Technical Service Bulletin

87 Faint high-frequency noise in the instrument panel area during A/C operation

87 19 00 2056182/2 October 22, 2019. Supersedes Technical Service Bulletin Group 87 number 19-97 dated September 20, 2019 for reasons listed below.

Model(s)	Year	VIN Range	Vehicle-Specific Equipment
RS3	2017 – 2020	All	Not Applicable

Figure 1. Balance weight positioning on the low side refrigerant line.

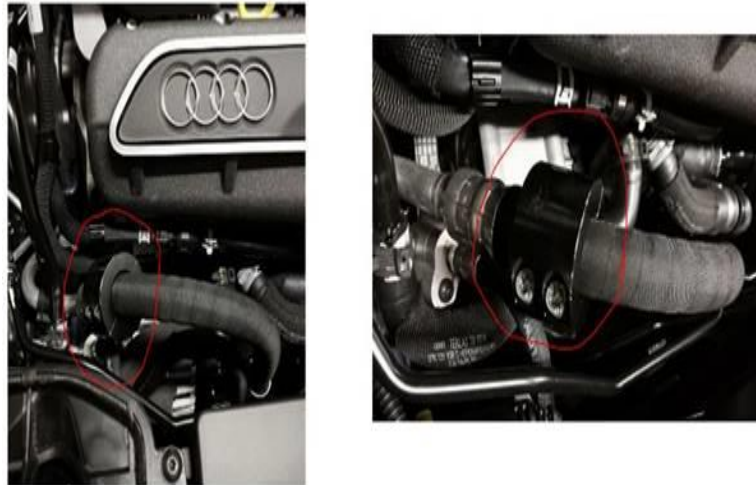
Do not replace the air conditioning compressor for this condition. Compressor replacement will not eliminate this noise. Reproduce the customer concern. The solution described in this TSB is only relevant to the vehicles for which this TSB appears.

1. Install balance weight part number 5Q0 820 899 on the refrigerant line (Figure 1). Install the balance weight using 2 bolts part number WHT 003 121. Apply medium strength thread locking compound to the bolts such as locking fluid D 185 410 A2.
